**Department of Energy**  
Carlsbad Field Office  
P. O. Box 3090  
Carlsbad, New Mexico 88221  
September 22, 2005

Subject: Response to NMED/HWB September 1, 2005 Notice of Deficiency (NOD), Consolidated Response to NOD Class 3 Permit Modification Request (PMR) Submitted in Accordance with P. L. No. 108-137, Section 311, and Second NOD for RH TRU Waste, WIPP Hazardous Waste Facility Permit (HWFP), EPA ID No. NM4890139088

**NMED/HWB September 1, 2005 Notice of Deficiency (NOD),  
Consolidated Response to NOD Class 3 Permit Modification Request  
Submitted in Accordance with P. L. No. 108-137, Section 311, and Second NOD  
for RH TRU Waste, WIPP Hazardous Waste Facility Permit,  
EPA ID No. NM4890139088-TSDF**

**Figure B7-2**  
**WASTE STREAM APPROVAL PROCESS**

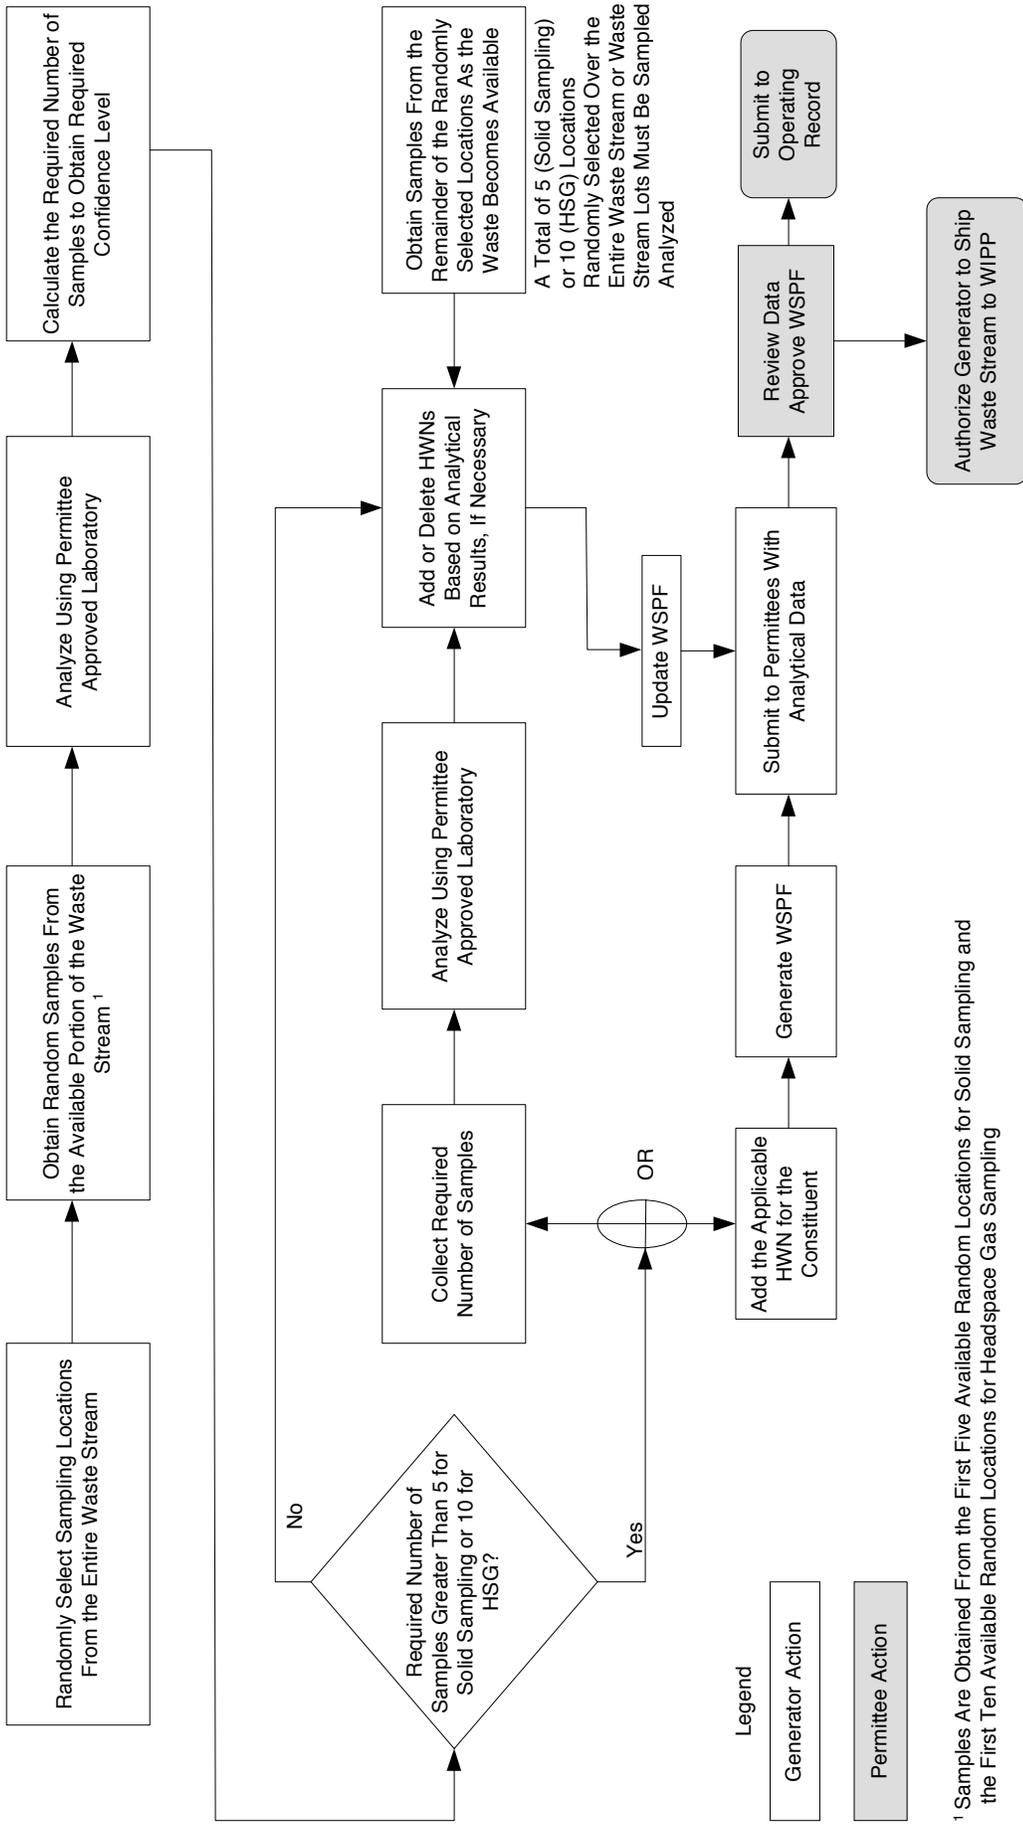
#### Attachment B7, Figure B7-2, Waste Stream Approval Process

In addition, Figure 1 implies that sites have the option of deciding whether to pursue the AK sufficiency determination vs. reduced sampling and analysis route, but language in the text of the PMR implies that the reduced sampling and analysis route will only be an option once an AK sufficiency determination is denied. The Permittees should resolve this inconsistency.

The figure should also provide another box after the “reject WSPF” box that indicates what the next action is regarding the rejected waste/form. NMED assumes that Figure 1

is a correct representation of the proposed process, assuming that it can be revised to indicate what will take place when a rejection of a WSPF or any other type of rejection is adequately portrayed.

- Block 4, Change Figure 2 to Figure B7-6
- Block 13, Change the “Ok?” to “Provisional Approval?”
- Block 14, Change to read “Submit Request for NMED to Evaluate Permittees’ Provisional Approval of AK Sufficiency Determination”

- Block 15 Change to read “NMED Determines Permittees’ Provisional Approval is Adequate
- Block 15a “Permittees Approve AK Sufficiency Determination”

Figure 1 is the same figure as Figure B7-2.

Figure 1 is consistent with the text in Section B7-1a. That is, if the differences and discrepancies identified by the Permittees during review of a WSPF cannot be resolved adequately by the generator, the WSPF and the waste stream are rejected and cannot be shipped to WIPP. That is why the “Reject WSPF” block is a terminal block. Such rejections would only occur if the generator cannot identify methods to resolve the Permittees concerns with the waste stream. If, after rejection of the WSPF, the generator decides that remediation of the waste stream is possible in order to make it WIPP acceptable, a new profile will be needed after remediation. Therefore, the Permittees have not incorporated the proposed change.

Attachment B7, Figure B7-2, change “per Figure 2” in Box 4 to “per Figure B7-6”.

Figure B7-6 APPROACH FOR SOLID AND HEADSPACE GAS SAMPLING AND ANALYSIS TO OBTAIN SUPPLEMENTAL WASTE ANALYSIS INFORMATION

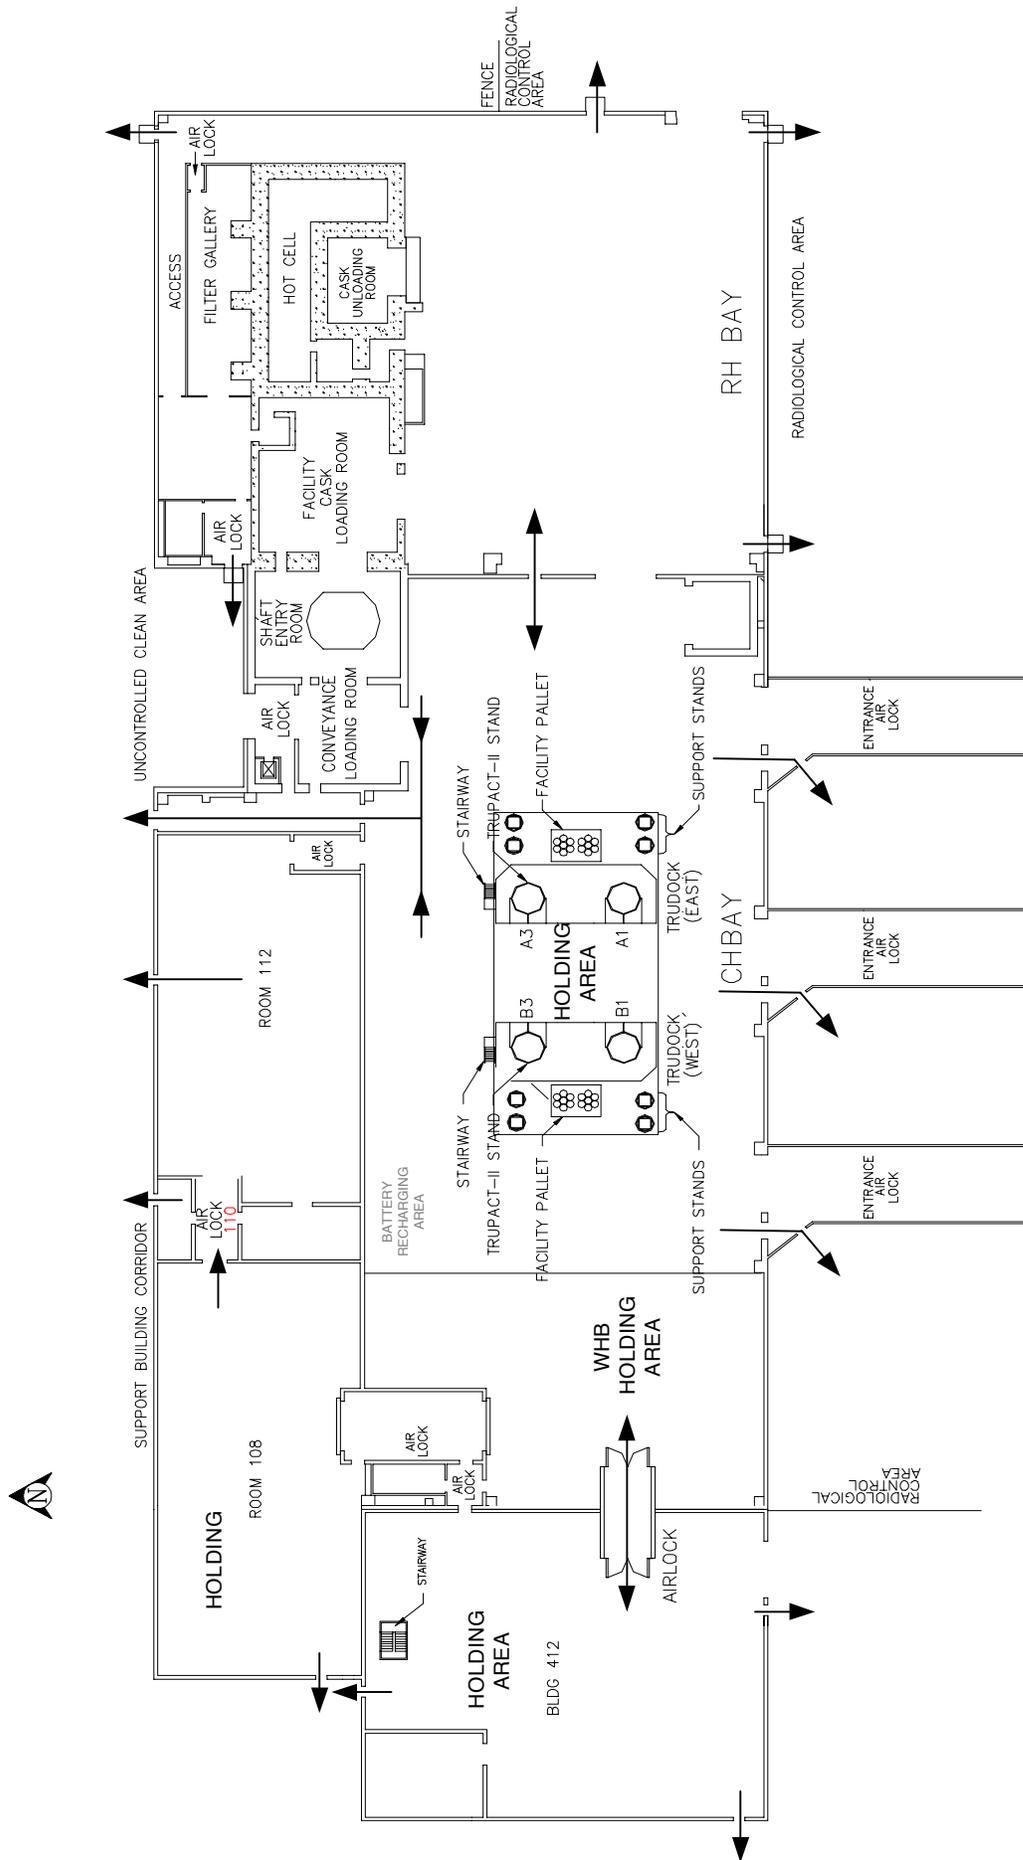
Process flow diagram *Figure 2, Approach for Solid and Headspace Gas Sampling and Analysis to Obtain Supplemental Waste Analysis Information*, also appears in the introduction of the Consolidated Response Document narrative. This figure should be incorporated into Attachment B7, so that the figure is part of the actual permit.

The Permittees agree and have added Figure B7-6, Approach for Solid and Headspace Gas Sampling and Analysis to Obtain Supplemental Waste Analysis Information.

Attachment B7, **Add Figure B7-6**, *Approach for Solid and Headspace Gas Sampling and Analysis to Obtain Supplemental Waste Analysis Information*. This figure is included in Attachment A.

**Figure M1-1**  
**Waste Handling Building - Container Storage and Holding Areas**

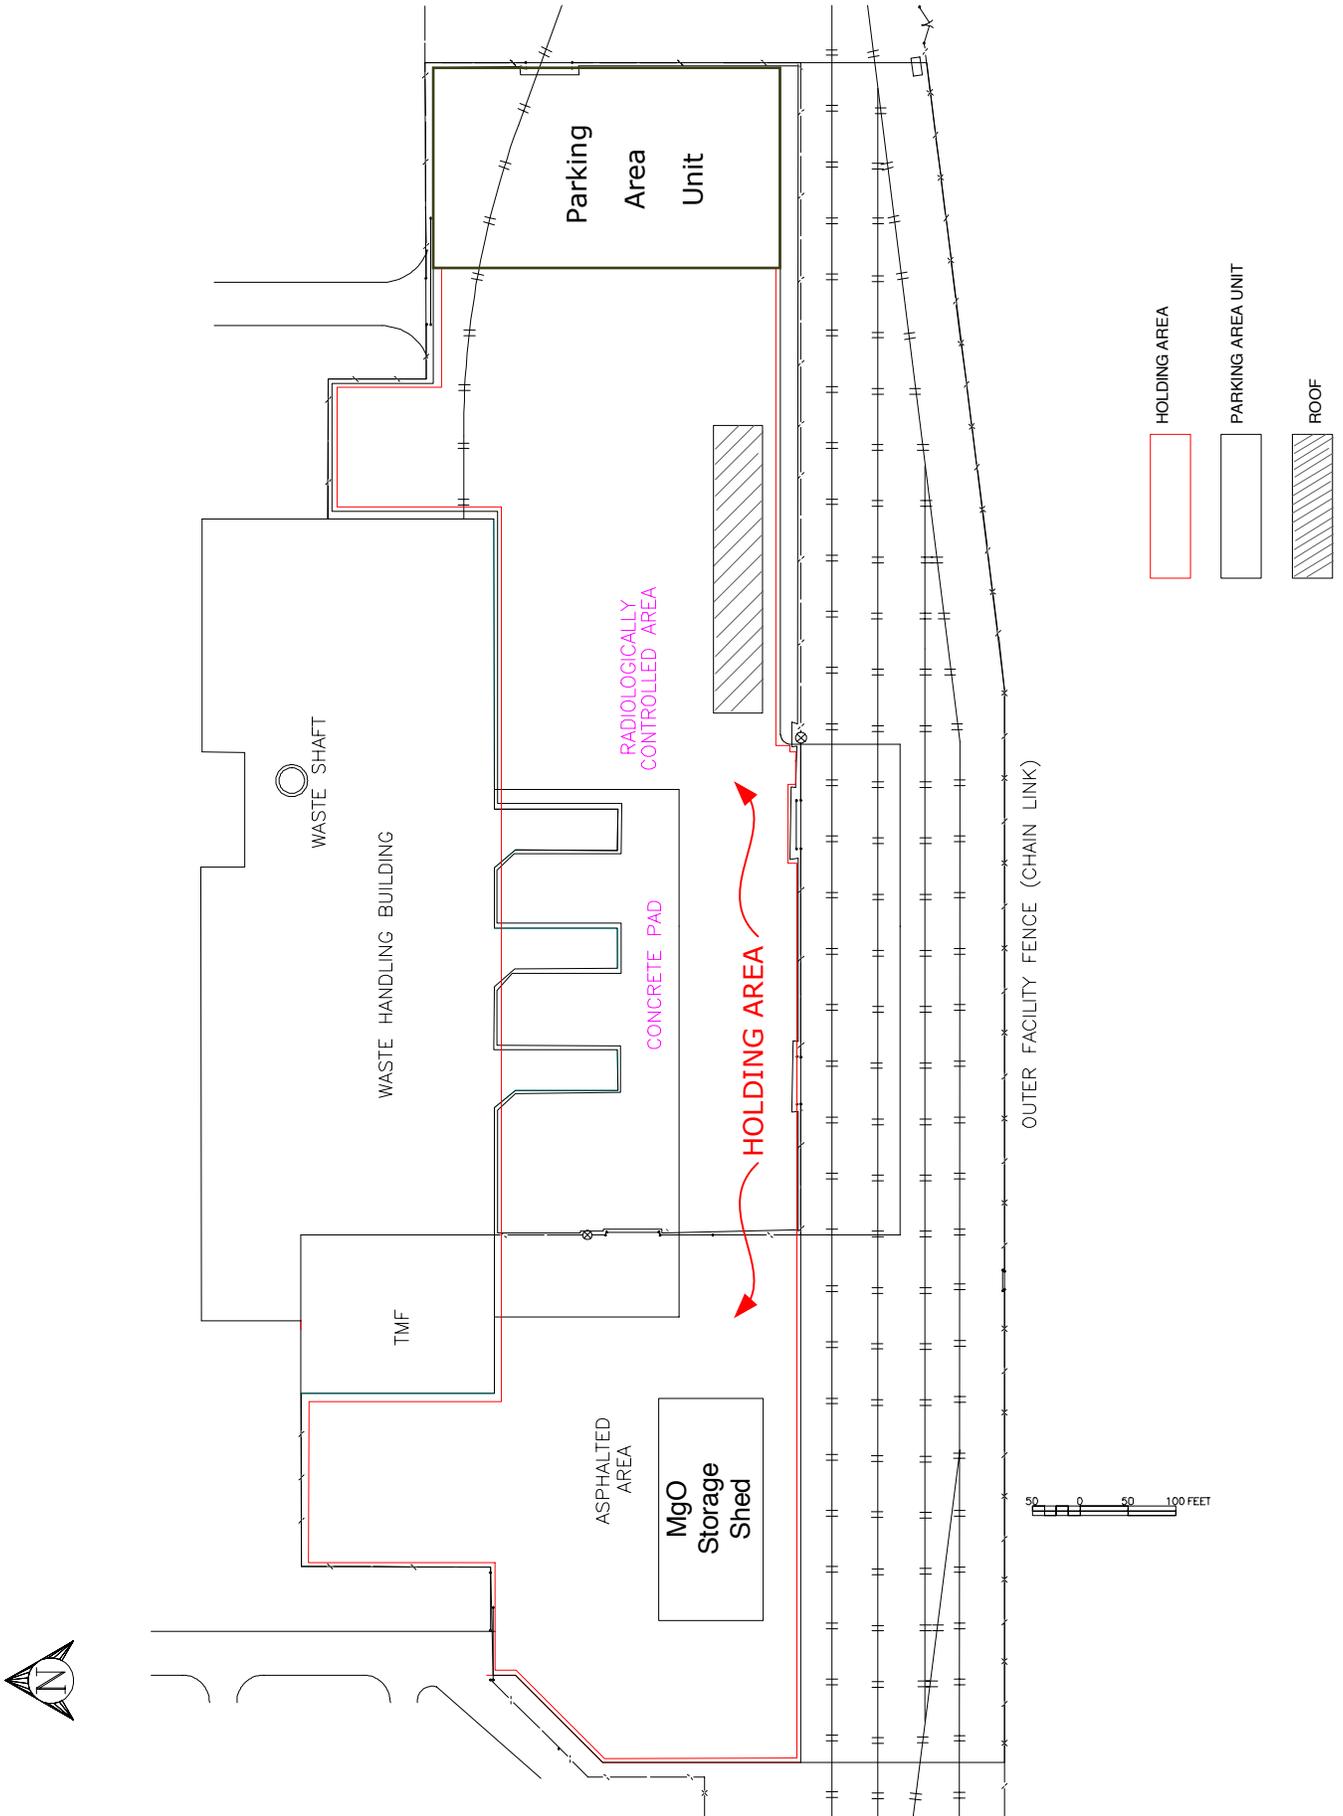
- a) Module III, Section III.A.1., *Waste Handling Building Container Storage Unit*, page III-1, 2<sup>nd</sup> paragraph
- b) Attachment M1, Figure M1-1, *Waste Handling Building- Container Storage and Staging Areas*; and Figures M1-17a, b and c, (*RH Bay and other RH rooms*)

Within Attachment M1, Figure M1-1, the CH Bay Storage Area is clearly delineated.

Table III.A.1 shows that the TRUDOCK Storage Area and NE Storage Area will be eliminated. Figure M1-1 shows that the TRUDOCK Storage Area will become a holding area and that the NE Storage Area is encompassed into the CH Bay Storage Area. Since the TRUDOCK Storage Area will become a holding area it will require closure.

To address this NMED comment, the word “staging” must be changed to “holding” in the following portions of the PMR: Modules I and III, Attachments A, C, D, E, F, G, I, M, M1, M2. Figures F-8c, G-3, G-7, M1-1, M1-2, M1-13, M2-12, O3-3 and O3-4, have been revised to reflect this change and are included in Attachment A of this response. Figure M1-7 has been deleted.

Two areas are proposed to undergo closure for conversion to Holding Areas. The first area is labeled “TRUDOCK Storage Area” in Figure M1-1 of the HWFP. This area is proposed to become the TRUDOCK Holding Area as shown in Figure M1-1 of the PMR.

**Figure M1-2**  
**Parking Area - Container Holding and Storage Areas**

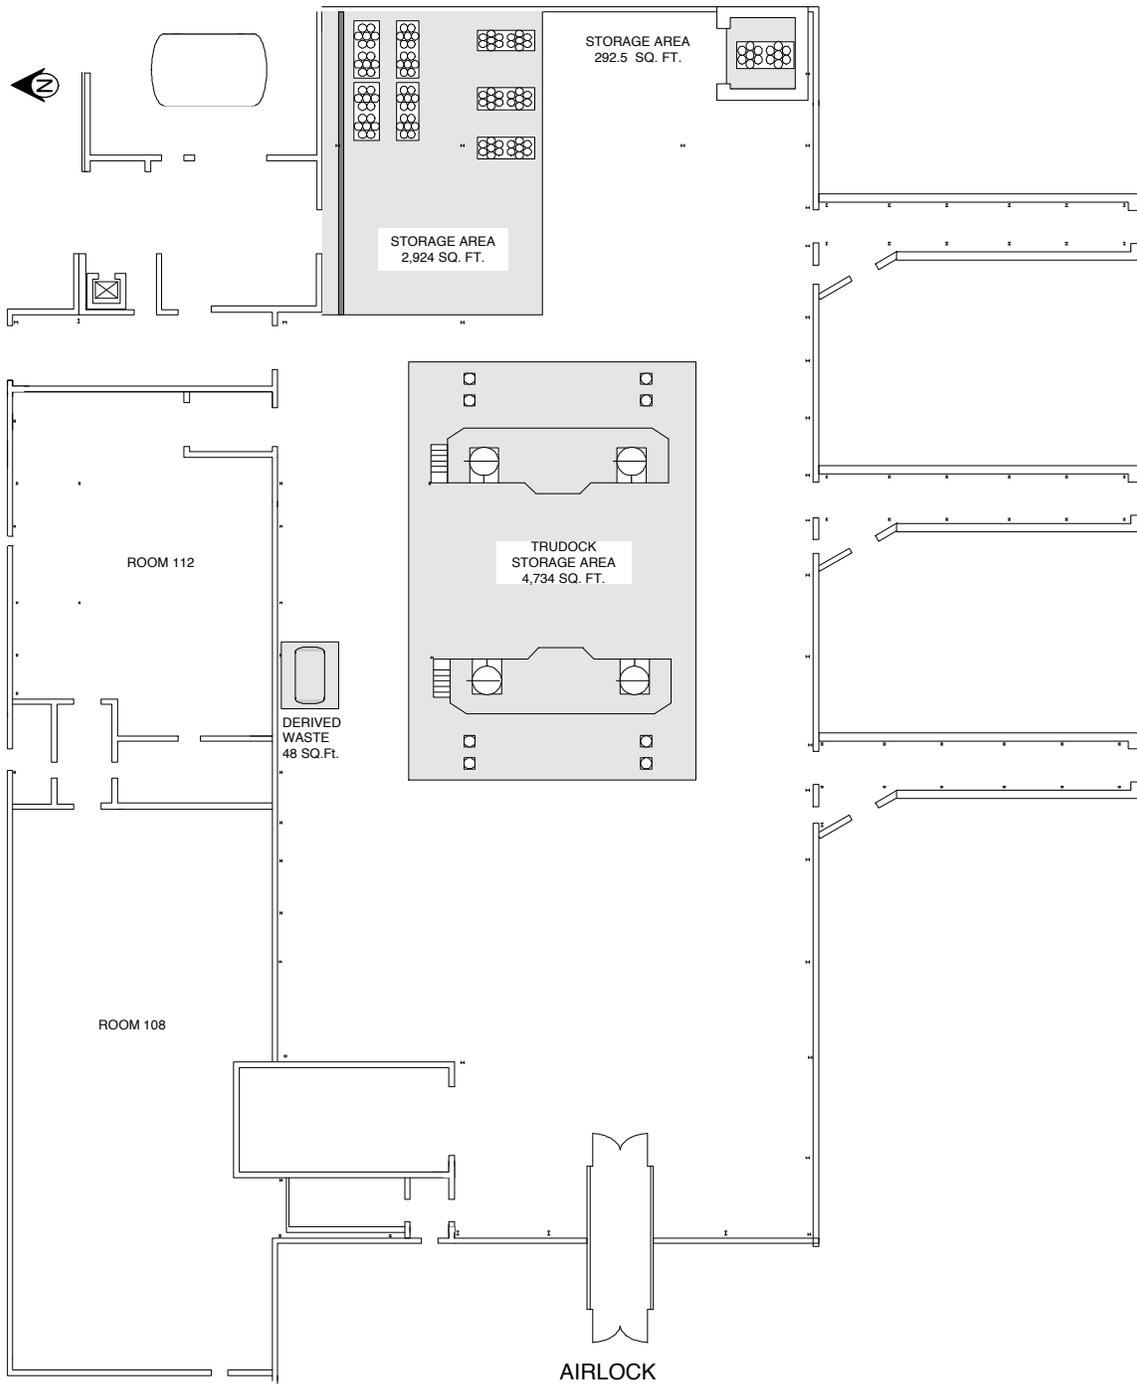
- a) Module III, Table III.A.2- *Parking Area Unit*, page III-4
- b) Attachment M1, Figure M1-2, *Parking Area- Container Staging and Storage Areas*

Within Attachment M1, Figure M1-2, the Parking Area Storage Unit and Parking Area Holding Unit are clearly delineated and are further restated in Tables III.A.2 and A-2. Also, the footnote of Table II.A.2 states:

The second area is a portion of the PAU shown in Figure M1-2 of the HWFP. The portion that is being converted to a Holding Area is shown in Figure M1-2 of the PMR.
